**Subject:** FW: EPR/WP3325SE/A001 We Need More Information About Your Application CRM:0297025  
**Attachments:** Raw Materials quantities.docx; Appendix6-Odour and Noise Management Plan.docx; Appendix1\_Non\_Technical\_Summary.docx

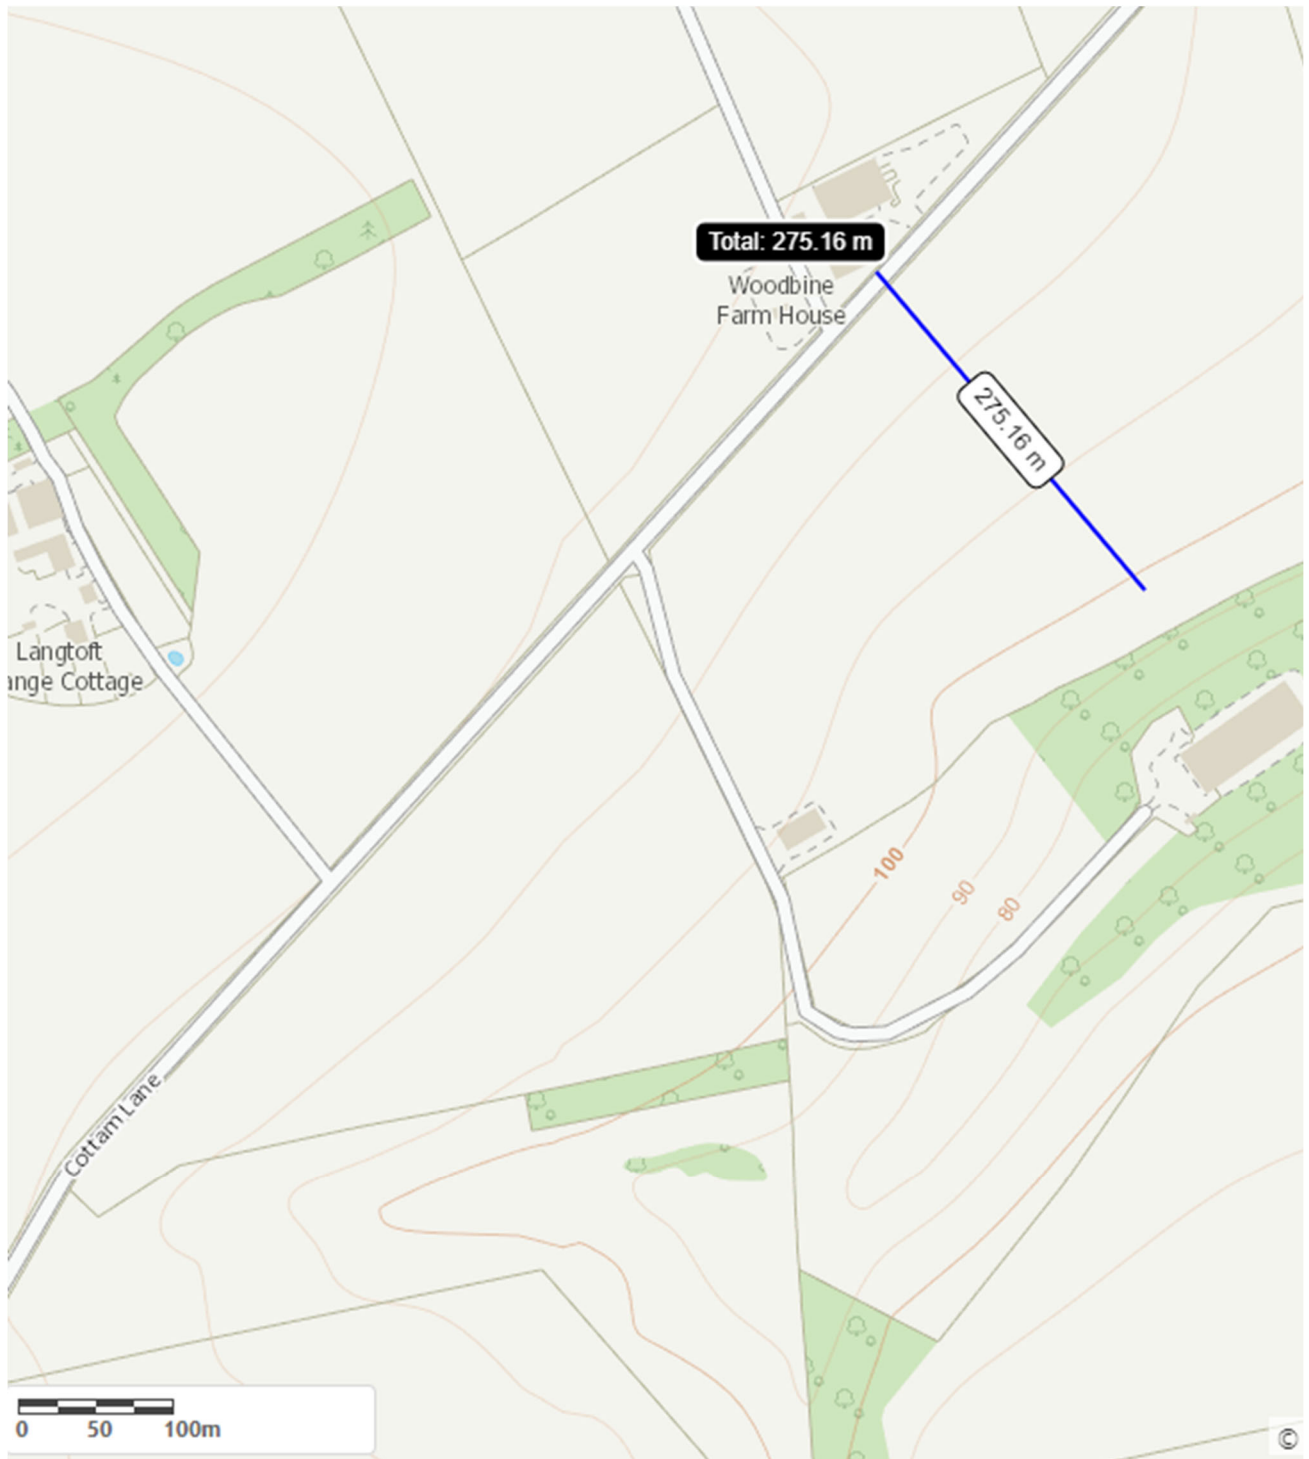
Question 7. Yes you will need to include Woodbine Farm in your noise and odour management plans as the distance is from Dale Farm installation boundary, so from looking at your new installation boundary provided, Woodbine farm is approx. 275m away (see screenshot below). Its the distance to the the property border, rather than to the Woodbine farmhouse itself. Hope that makes sense. Please reply to questions 7a, 7b and 7c and supply the revised noise and odour management plans. **Please see attached revised Odour and noise document.**
